Work Order ID 138028

Item ID: D206-667-147TRN Accept ***N900040100*** Setup Start ***NS1***
 Revision ID: Stop ***NS2***
 Item Name: Crosstube Assembly, Mid Fwd
 Start Date: 10/20/2015 Start Qty: 1.00 ***1*** Cust Item ID:
 Required Date: 11/3/2015 Req'd Qty: 1.00 ***1*** Customer:
 Reference:

DART AEROSPACE LTD HAWKESBURY, ONTARIO, CANADA	
DRAWING NO. D206-667-147	REV. A SHEET 1 OF 4
TITLE CROSSTUBE ASS'Y (206L MID FWD)	SCALE NTS
COPYRIGHT © 2010 BY DART AEROSPACE LTD THIS DOCUMENT IS PRIVATE AND CONFIDENTIAL AND IS SUPPLIED ON THE EXPRESS CONDITION THAT IT IS NOT TO BE USED FOR ANY PURPOSES OR COPIED OR REPRODUCED IN ANY MANNER WITHOUT WRITTEN PERMISSION FROM DART AEROSPACE LTD.

DRAWING NO. D206-667-147	TITLE CROSSTUBE ASS'Y (206L MID FWD)	REV. A	DART AEROSPACE LTD ENGINEERING ORDER		D.E.O. NO. D206-667-147-A-1	SHEET NO. SHEET 1 OF 1	SCALE NTS
DRAWN <i>Q</i>	CHECKED <i>ASS</i>	MFG. APPR. <i>JB</i>	APPROVED <i>MD</i>		DE APPR. <i>MD</i>		
DATE 11.07.15	DATE 11.07.20	DATE 11.07.21	DATE 11/07/21		DATE 11.07.21

DETAIL P
BONDING STRAP INSTALLATION 2 PL

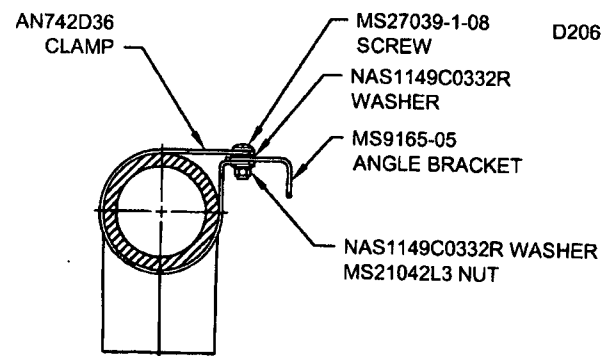
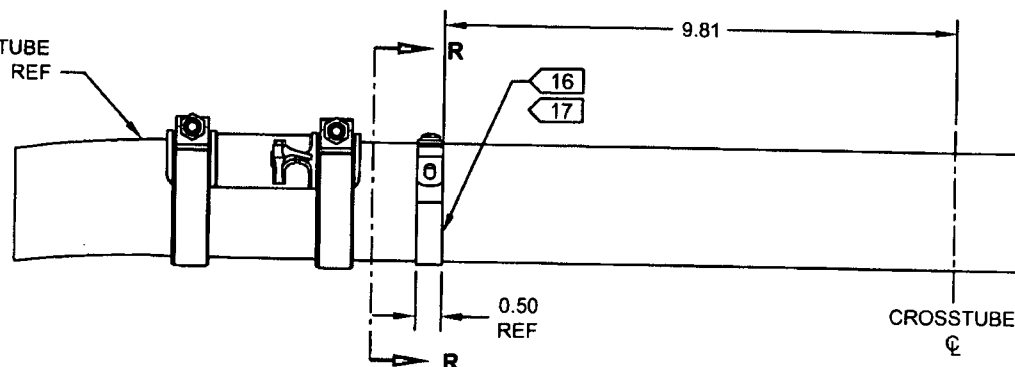
PURPOSE:

ADD ELECTRICAL GROUNDING STRAP

PARTS LIST:

ITEM	QTY -147	PART NUMBER	DESCRIPTION
1	X	D206-667-147	CROSSTUBE ASSEMBLY (206L MID FWD)
10	2	AN742D36	CLAMP
11	2	MS9165-05	ANGLE BRACKET
12	2	MS21042L3	NUT (OR MS21042-3)
13	2	MS27039-1-08	SCREW
14	4	NAS1149C0332R	WASHER (OR AN960C10L)

- 16) MASK AREA UNDER CLAMP PRIOR TO PAINTING
- 17) SEAL EDGES WHERE AN742D36 CLAMP MEETS WITH THE CROSSTUBE USING SIKAFLEX-241/-291 OR MIL-S-8802 CLASS B2 OR PROSEAL 890 SEALANT
- 18) PERFORM RESISTANCE CHECK TO ENSURE MAX RESISTANCE IS 10 MILLIOHMS

WALL THICKNESS MEASUREMENT

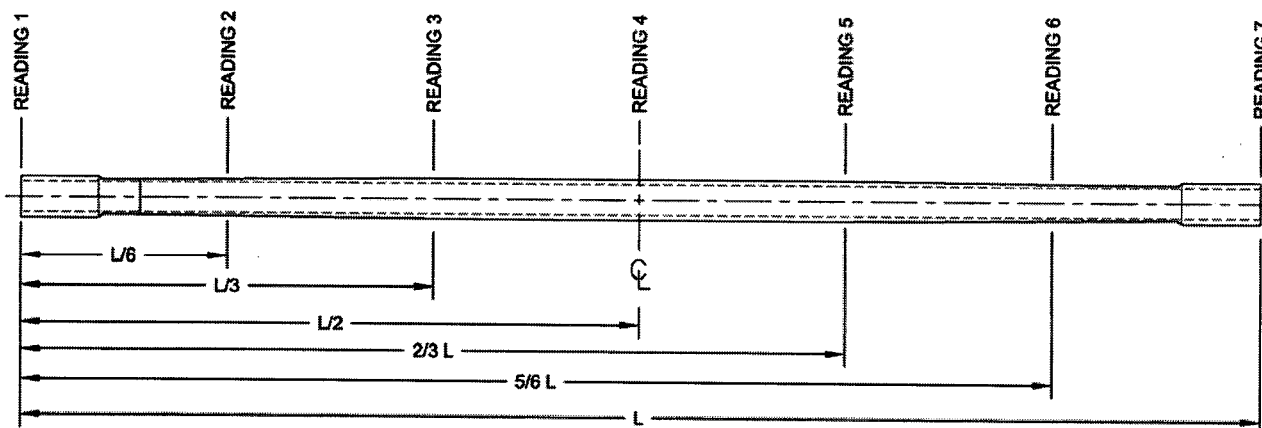
Machining ☐	Small Fab ☐	Prod. Eng. Coord. ☐	Quality ☐																																																																				
Thermoforming ☐	Finishing ☐	Rec/Store/Packaging ☐	Other ☐																																																																				
Large Fab ☐	Composite ☐	Supplier ☐																																																																					
Date: 15/10/26		Step #: 100		QTY Effective: 1		MRB (QSI042) Approval DAS 12 9-89 15/10/26																																																																	
Description Work Order Deviation				Disposition																																																																			
Well thickness measurement is over tolerance. $\begin{array}{r} \text{Min well} = 0.154 \\ \text{Dwg} = 0.164 \\ \hline \Delta = -0.010 \end{array}$				Min well is within allowable of raw mat'l.				Completed By DAS 12 9-89 15/10/26 Lead hand / Supervisor DAS 47 9-89 15-10-28 QC / QA Coordinator DAS 38 9-89 OCT 28 2015

Past Expiry Date ☐	Manufacturing Process ☐																																																																						
Misidentified ☐	Past Due ☐																																																																						
Pressure/Forced ☐	Temperature/Cure ☐	Power Loss/Surge ☐	Positioned Wrong ☐																																																																				
Bending ☐	Set-up ☐	Folio/Program ☐	Outside Dimensions ☐																																																																				
Centre Not Concentric ☒	BOM/Route ☐	Grain ☐	Over/Under tolerance ☒																																																																				
Cracks ☐	Broken/Damage/Defect ☐	Weld ☐	Part Incorrect ☐																																																																				
Crimp/Kink/Ripple/Wave ☐	Inspection Incomplete/Unqualified ☐	Wrong Stock Pulled ☐	Part Lost/Missing ☐																																																																				
Cuffs ☐	Contamination ☐	Out of Sequence ☐	Part Moved ☐

Work Order: <u>138628</u> Part No. <u>1226-667197 TRN</u> NCR No. <u>15-5411</u>		DISPOSITION Rework ☐ Scrap ☐ Use-as-is ☒ Suspected Unapproved ☐		AGAINST DEPARTMENT/PROCESS <table style="width:100%;"> <tr> <td>Skid-tube ☐</td> <td>Cross tube ☒</td> <td>Water Jet ☐</td> <td>Engineering ☐</td> </tr> <tr> <td>Machining ☐</td> <td>Small Fab ☐</td> <td>Prod. Eng. Coord. ☐</td> <td>Quality ☐</td> </tr> <tr> <td>Thermoforming ☐</td> <td>Finishing ☐</td> <td>Rec/Store/Packaging ☐</td> <td>Other ☐</td> </tr> <tr> <td>Large Fab ☐</td> <td>Composite ☐</td> <td>Supplier ☐</td> <td></td> </tr> </table>				Skid-tube ☐	Cross tube ☒	Water Jet ☐	Engineering ☐	Machining ☐	Small Fab ☐	Prod. Eng. Coord. ☐	Quality ☐	Thermoforming ☐	Finishing ☐	Rec/Store/Packaging ☐	Other ☐	Large Fab ☐	Composite ☐	Supplier ☐																																																	
Skid-tube ☐	Cross tube ☒	Water Jet ☐	Engineering ☐
